STAFF RECOMMENDATION

1411 Forrest Avenue
February 21, 2018

Application: Demolition; New construction-infill
District: Lockeland Springs-East End Neighborhood Conservation Zoning Overlay
Council District: 06
Map and Parcel Number: 08309036800
Applicant: Joe Spicer, Owner
Project Lead: Sean Alexander, sean.alexander@nashville.gov

Description of Project: The applicant proposes to demolish a non-contributing house and to construct a new one and one-half story house. The house will have a form similar to several historic Craftsman houses in the area, with a side-gabled roof, a gabled dormer on the front, and a full-width porch.

PHOTOGRAPHS

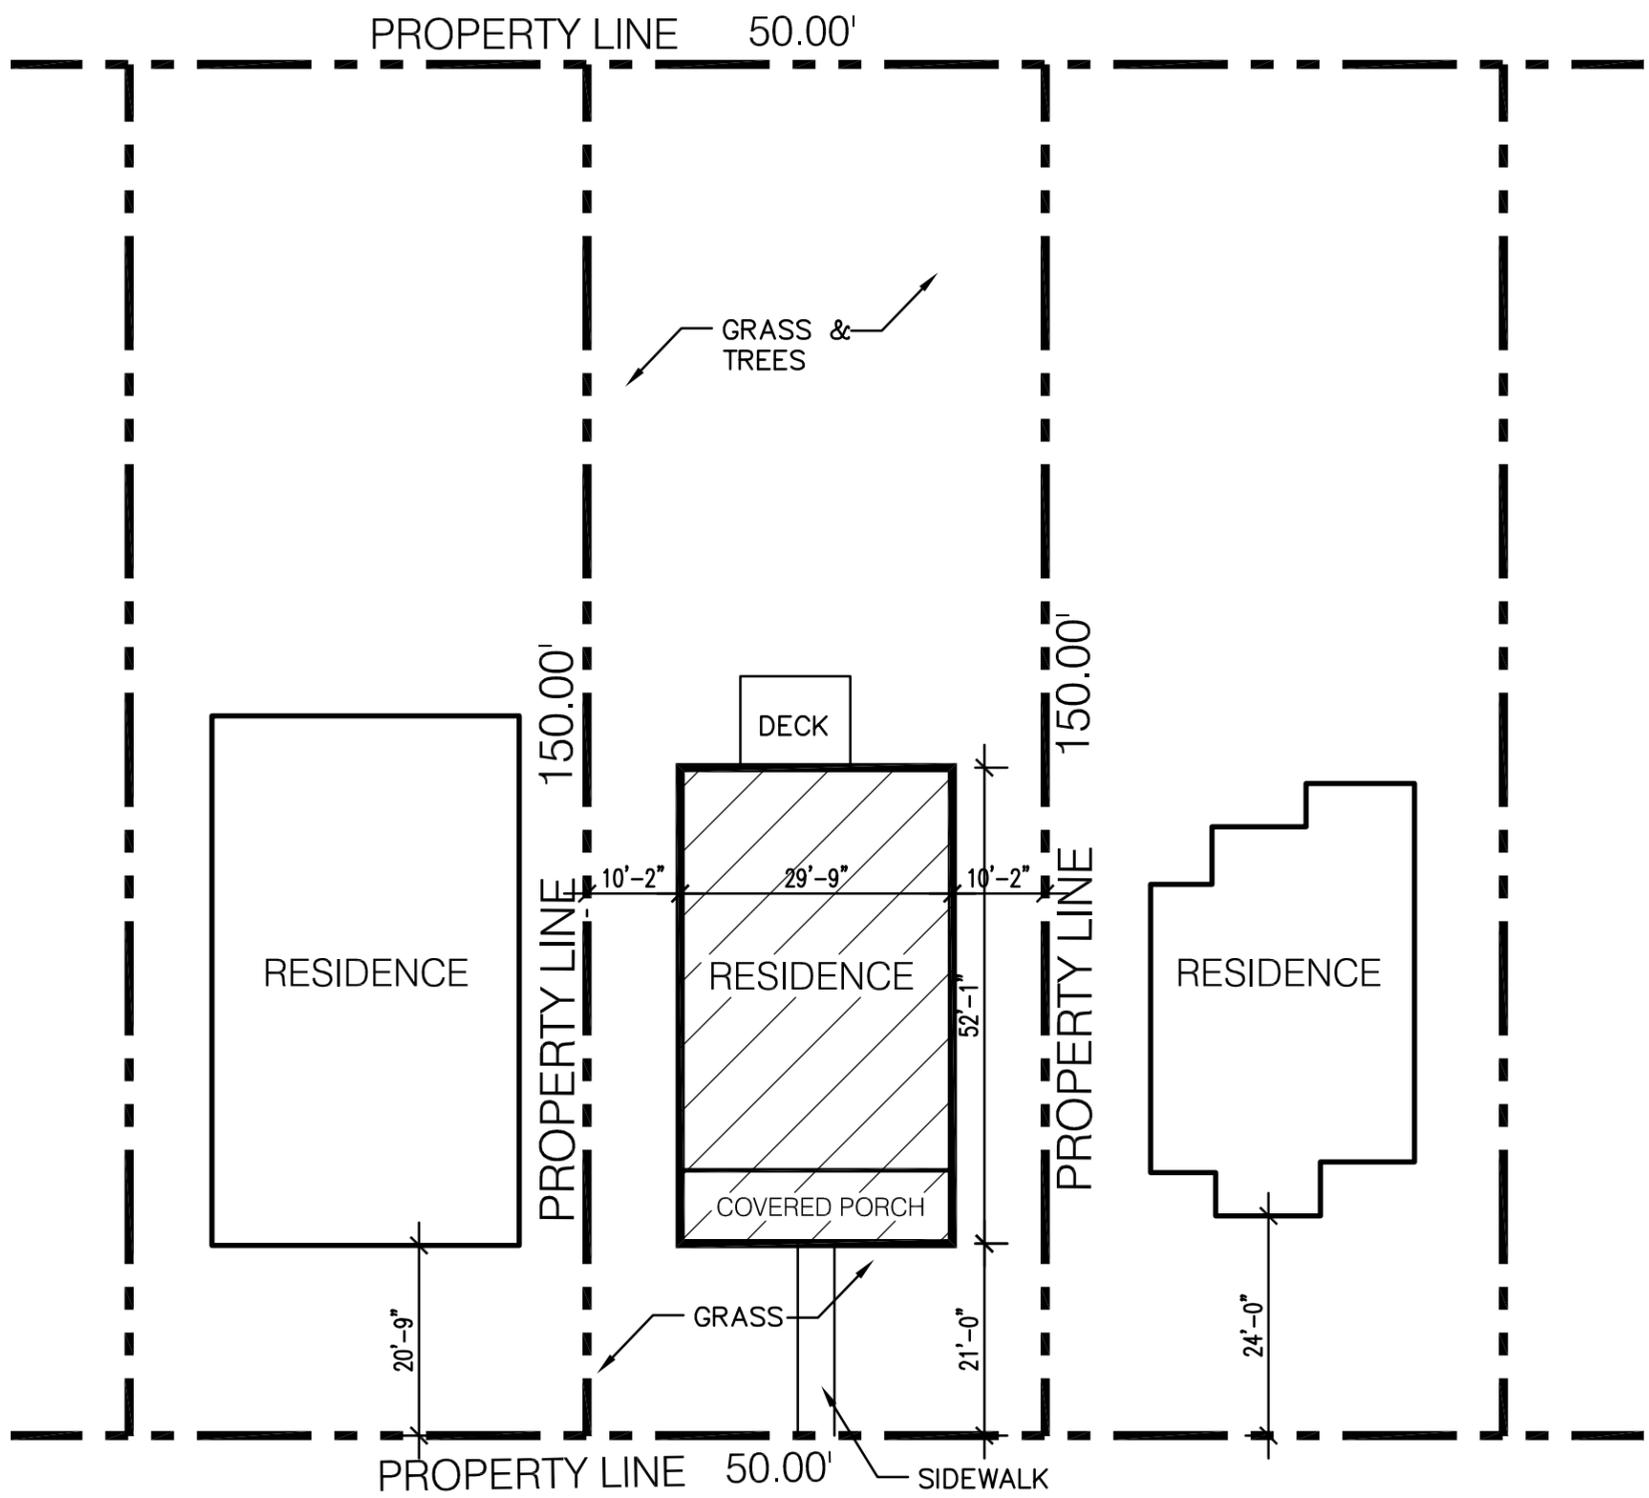
Existing non-contributing building at 1411 Forrest Avenue.

Demolition: The building's low slope roof, shallow eaves, and lack of architectural details are inconsistent with the historic character of the surrounding area. The surrounding context comprises mainly of one story and one and one-half story houses with large porches, in historic styles from the late nineteenth century through the middle of the twentieth century. Because the date of construction for this building is more recent and its architecture and materials are not representative of the area's significant periods of development, the house is not considered to be

contributing to the historic character of the district. Staff therefore finds that demolition meets Section III.B.2 for appropriate demolition and does not meet section III.B.1 for inappropriate demolition.

SITE PLAN

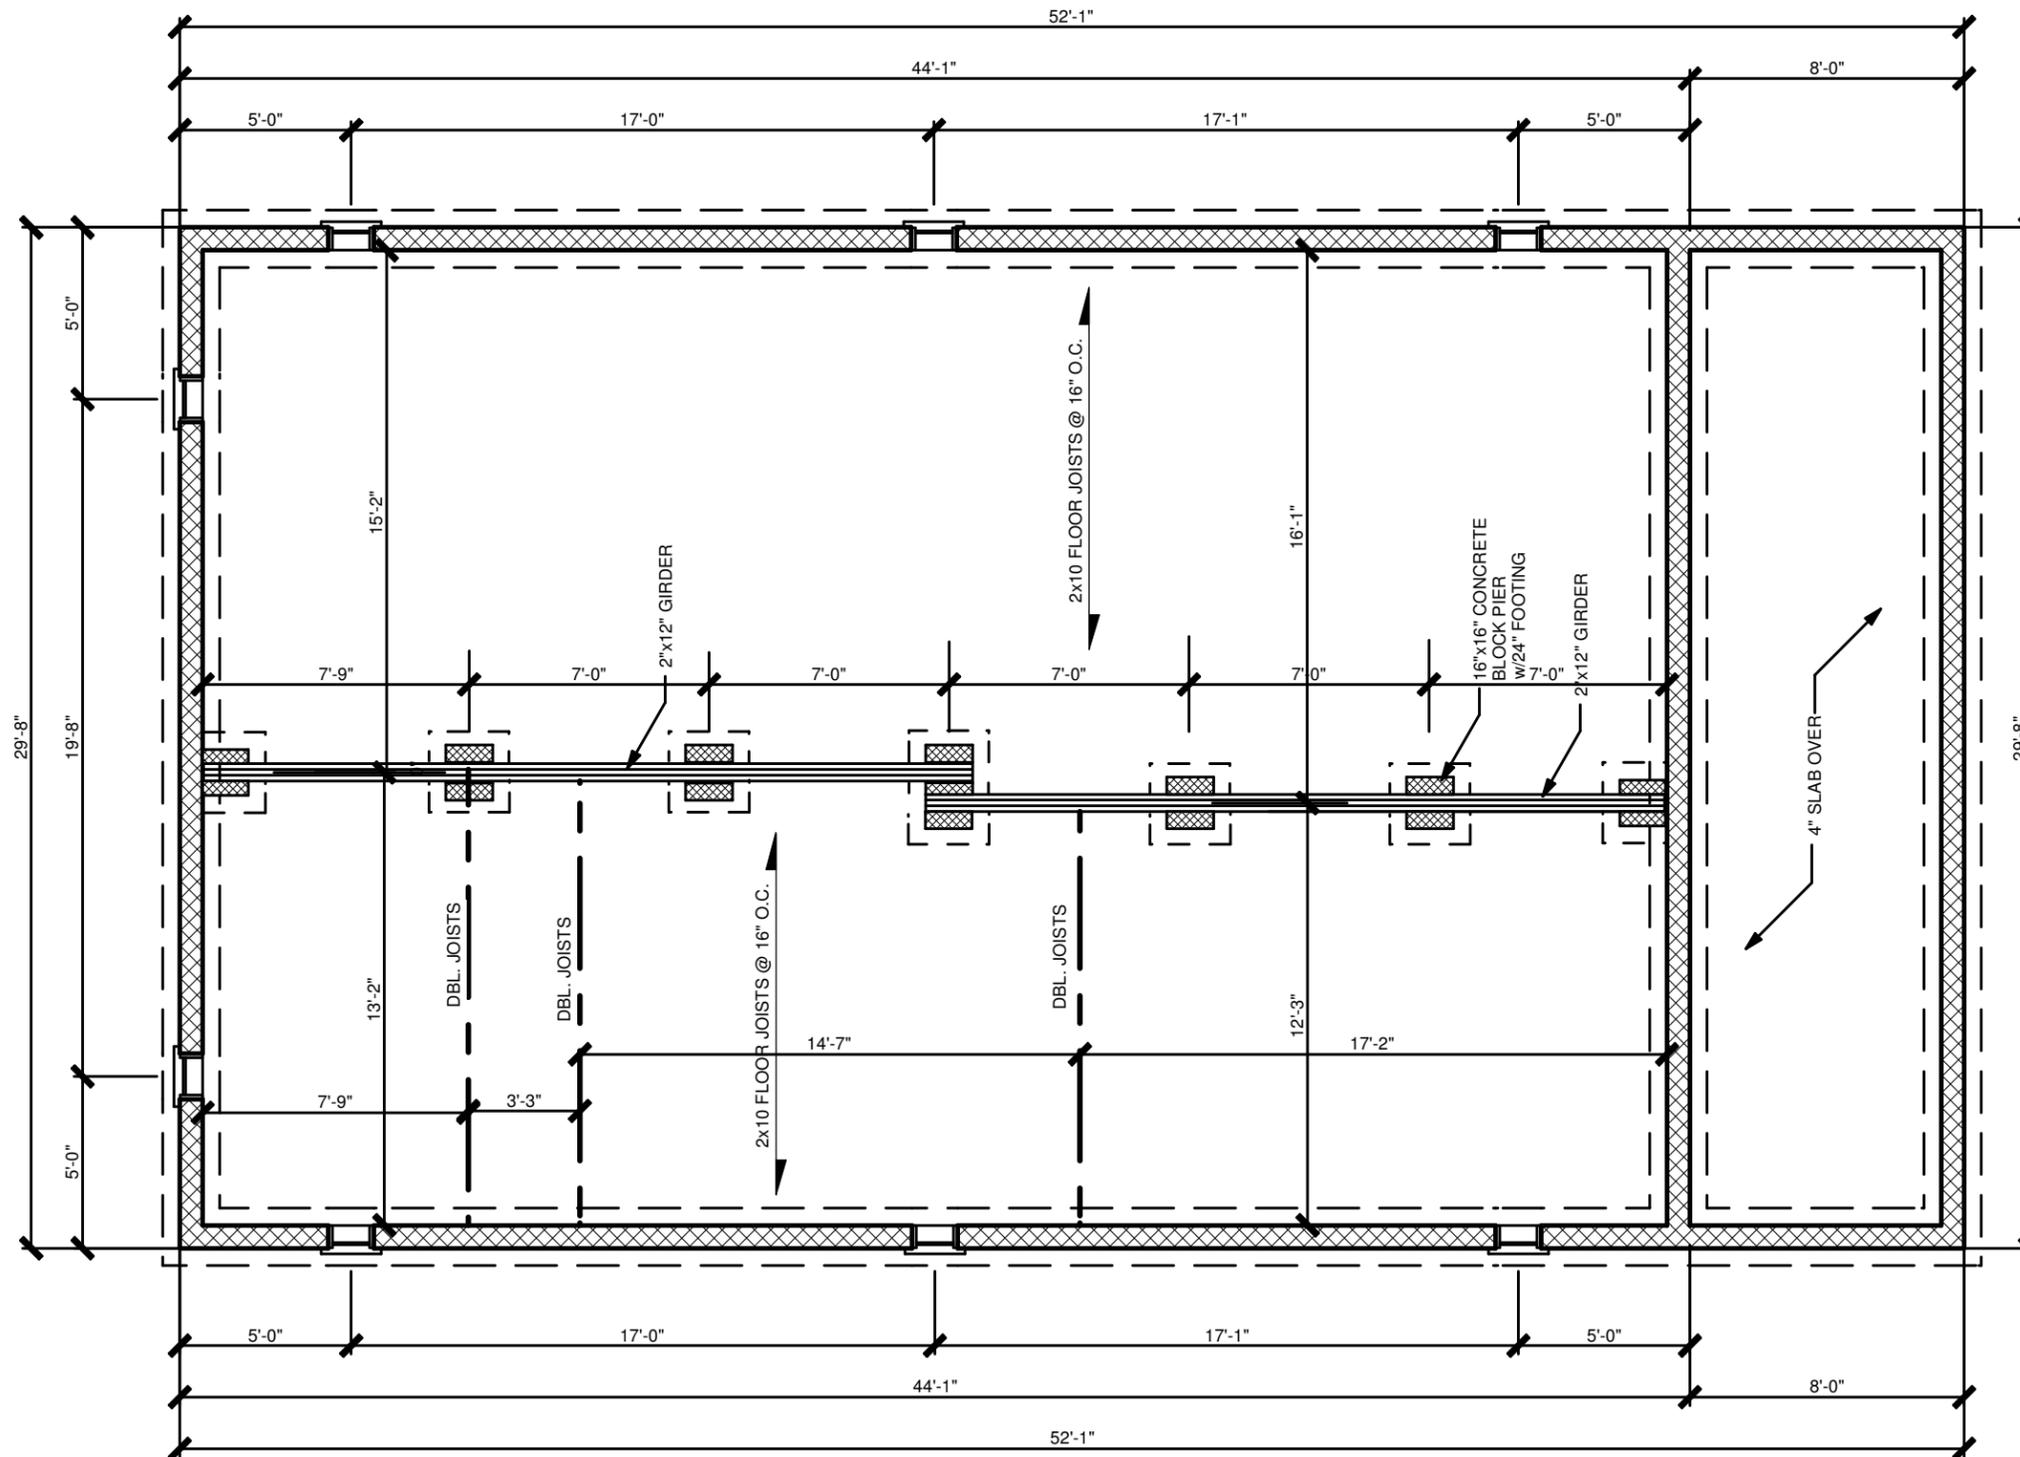
Setback & Rhythm of Spacing: The proposal shows that the building will be located with a front setback of twenty-one feet (21'), which is consistent with the setbacks of the buildings on either side. The new building would be centered on the lot, ten feet, two inches (10'-2") from both side property lines. Staff finds that the project would meet section II.B.3 of the design guidelines.

Appurtenances & Utilities: A walkway will connect from the front porch to the sidewalk, but the material of the walkway is not indicated on the plans. No other paving or other appurtenances were indicated on the drawings. Staff recommends that any parking areas or driveways be added to the site plan prior to issuing permit. In general, HVAC units should be located on the rear façade, or on a side façade beyond the midpoint of the house on the non-street-facing side. With that condition that the HVAC location and any other appurtenances are administratively approved and parking and walkways are added to the site plan, staff finds that the project will meet section II.B.9 of the design guidelines.

FRONT ELEVATION

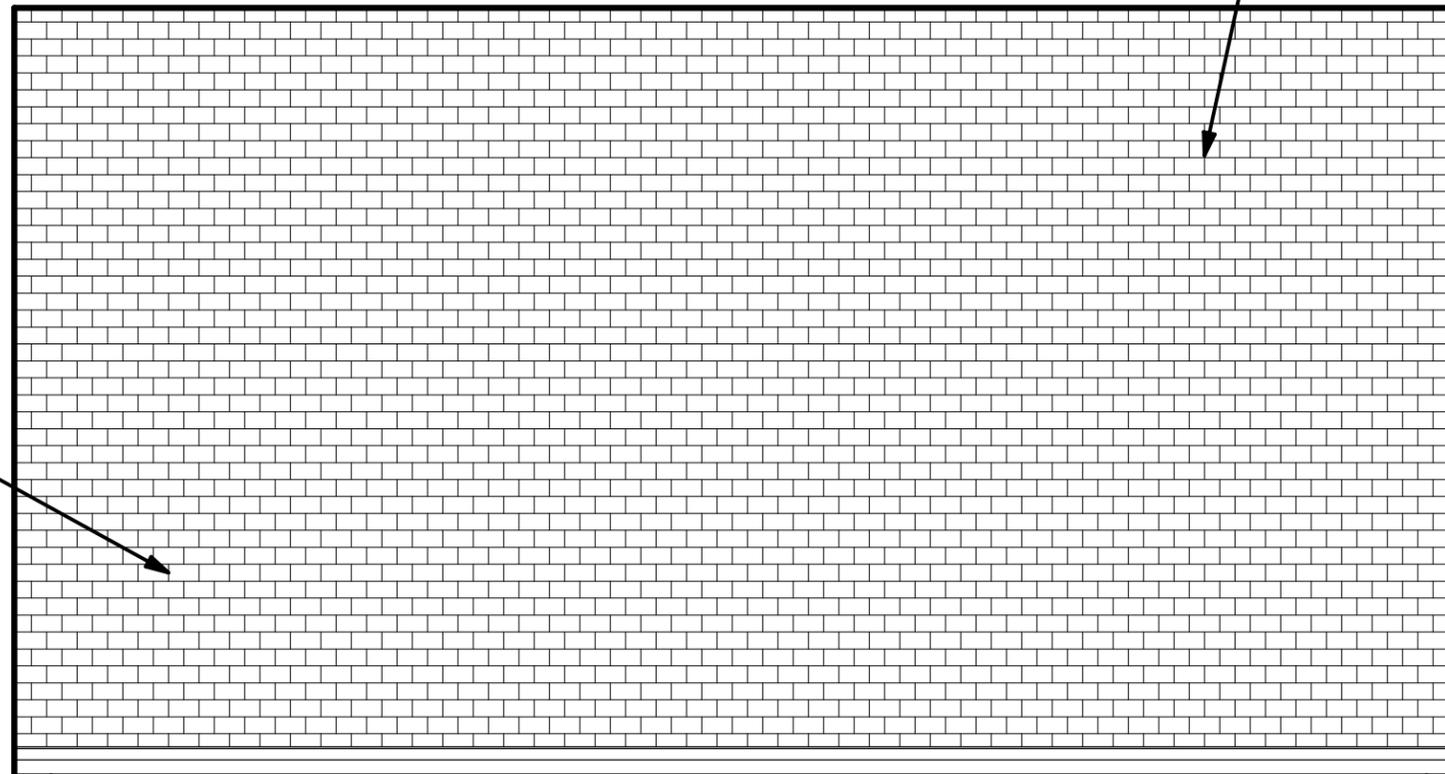
Height & Scale: The new house will be one one-half story, having a side-gabled form with a full-width front porch and a front-gabled dormer. This form is similar to several historic Craftsman style houses nearby. The house will be twenty-seven feet, six inches (27'-6") tall at the front, with a roof height of twenty-four feet, six inches (24'-6") above the floor level, an eave height of seven feet, eight inches (7'-8") above the floor, and an exposed foundation approximately two feet, four inches (2'-4") tall and an eight inch (8") thick floor on the porch. The grade of the lot rises toward the rear, where the foundation will only be a single course of block or approximately eight inches (8") tall. These heights are consistent with the heights of nearby historic houses, which range from twenty feet (20') to thirty-one feet (31') tall.

Roof form: The primary roof form on the house will be a side-oriented gabled with an 8:12 pitch, and the full-width front porch will have a 3:12 pitched shed roof. The front gabled dormer will have a pitch of 8:12, matching the primary roof form. These roofs are similar to those of several historic houses in the surrounding area. Staff finds the roof form and pitches to be compatible with roofs on surrounding historic houses and to meet section II.B.5 of the design guidelines.

Orientation: The primary facade of the new house will face Forrest Avenue directly, in the same direction and manner as historic buildings on the block. The house will have a clearly identifiable front facing Forrest Avenue with an eight foot (8') deep full width porch connected to the sidewalk by a paved walkway. Staff finds that the orientation of the project meets section II.B.6 of the design guidelines.

Proportion and Rhythm of Openings: The windows on the proposed new house will be vertical in orientation, spaced in a rhythm similar to what is typical of historic houses. The windows will be double hung with divided light sashes as is typical of historic houses, with four inch (4") mullions between paired sets. Staff finds that the new house will meet section II.B.7 of the design guidelines.
